DCR-PC7/PC7E

SERVICE MANUAL

SUPPLEMENT-1

ADDITION FOR SUPPLIED PARTS FOR LIQUID CRYSTAL DISPLAY PANEL SECTION

Page 5-3 **CABINET (R) AND LCD PANEL ASSEMBLIES**

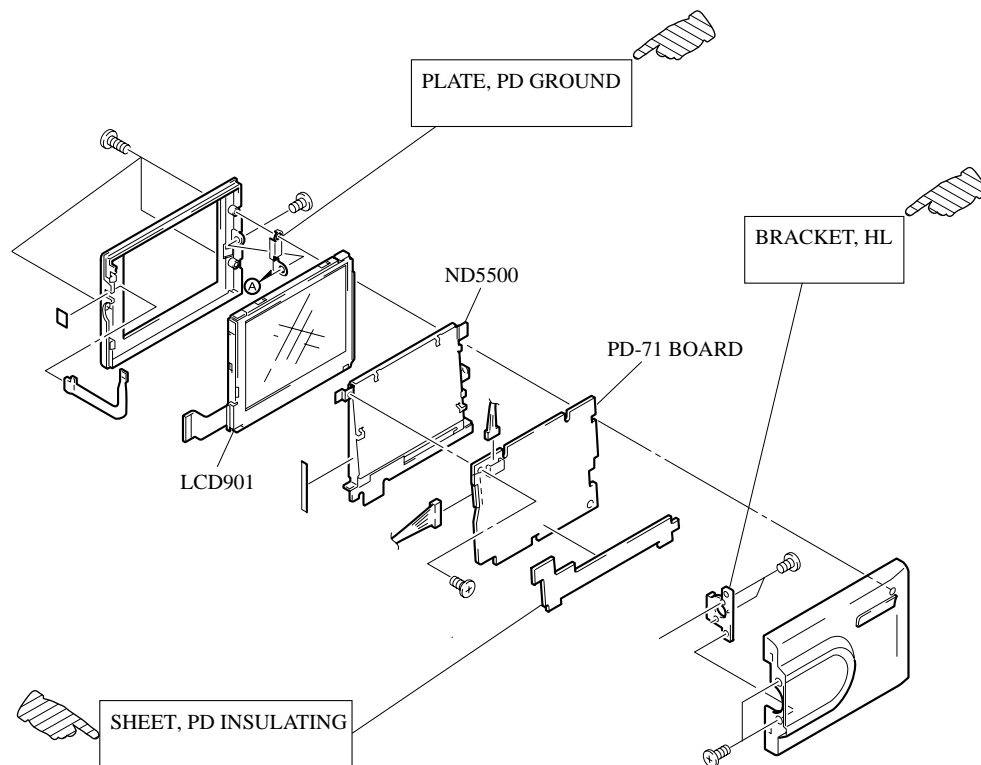
- The  mark parts of liquid crystal display panel section was not supplied. But it changed to one of supplied parts because it is necessary for servicing.
